UNITED STATES  
DEPARTMENT OF THE INTERIOR  
BUREAU OF LAND MANAGEMENTFORM APPROVED  
OMB NO. 1004-0135  
Expires: July 31, 2010**SUNDRY NOTICES AND REPORTS ON WELLS**  
*Do not use this form for proposals to drill or to re-enter an abandoned well. Use form 3160-3 (APD) for such proposals.*5. Lease Serial No.  
NMNM104610

# Coleman Oil & Gas, Inc.

## Final P&A Procedure Basin Fruitland Coal Formation WAW Fruitland Sand PC

Re: Permanent Abandonment  
Well: Chipper #1

**COLEMAN OIL GAS, INC.  
Chipper #1 PROPOSED P&A**

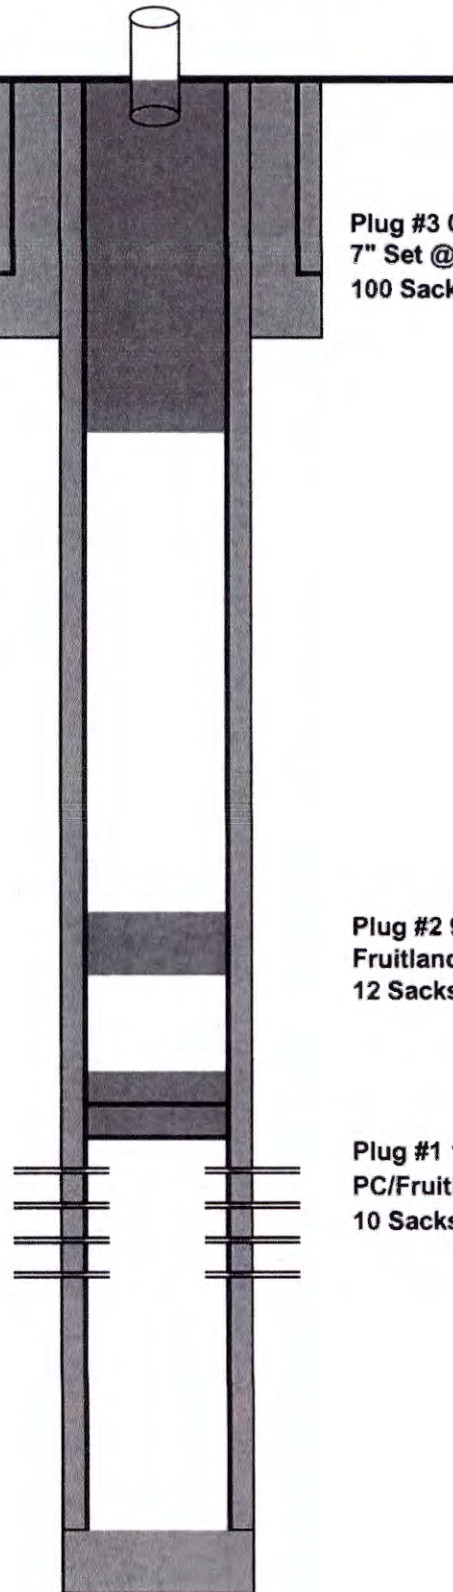
1. Plugging operations authorized are subject to the attached "General Requirements for Permanent Abandonment of Wells on Federal and Indian Lease."
2. Farmington Office is to be notified at least 24 hours before the plugging operations commence (505) 564-7750.
3. The following modifications to your plugging program are to be made:
  - a) Set Plug #1 (1295-1128) ft. to cover the Pictured Cliffs top and perforations. BLM picks top of Pictured Cliffs at 1245 ft.
  - b) Set plug #2 (1016-916) ft. to cover the Fruitland top. BLM picks top of Fruitland at 966 ft.

You are also required to place cement excesses per 4.2 and 4.4 of the attached General Requirements.
